IEC 62908-12-10
Edition 1.0 2017-06

TOUCH AND INTERACTIVE DISPLAYS –

Part 12-10: Measurement methods of touch displays – Touch and electrical performance

CORRIGENDUM 1

Figure 12 – Linearity definition

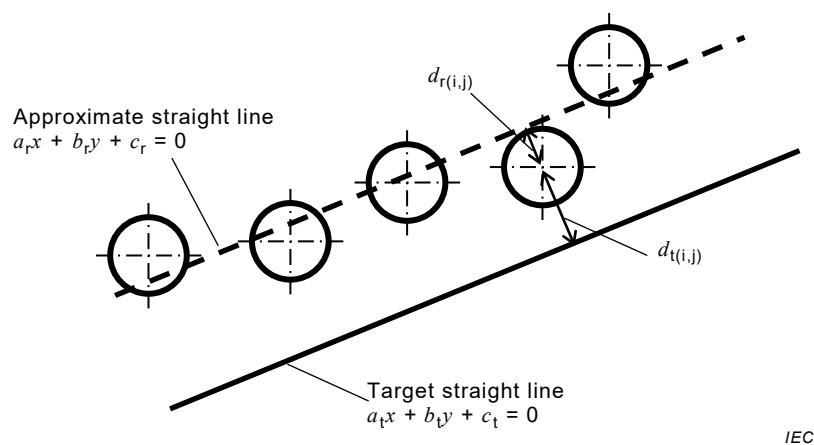
Replace the first sentence of the second paragraph with:

The distance between the centre of the reported point and straight line is calculated by the formula in Figure 12.

Replace Figure 12 with:

Replace Equations (17) and (18) with:

$$d_{r(i,j)} = \frac{|a_r x_{r(i,j)} + b_r y_{r(i,j)} + c_r|}{\sqrt{a_r^2 + b_r^2}} \quad (17)$$

$$d_{t(i,j)} = \frac{|a_t x_{r(i,j)} + b_t y_{r(i,j)} + c_t|}{\sqrt{a_t^2 + b_t^2}} \quad (18)$$
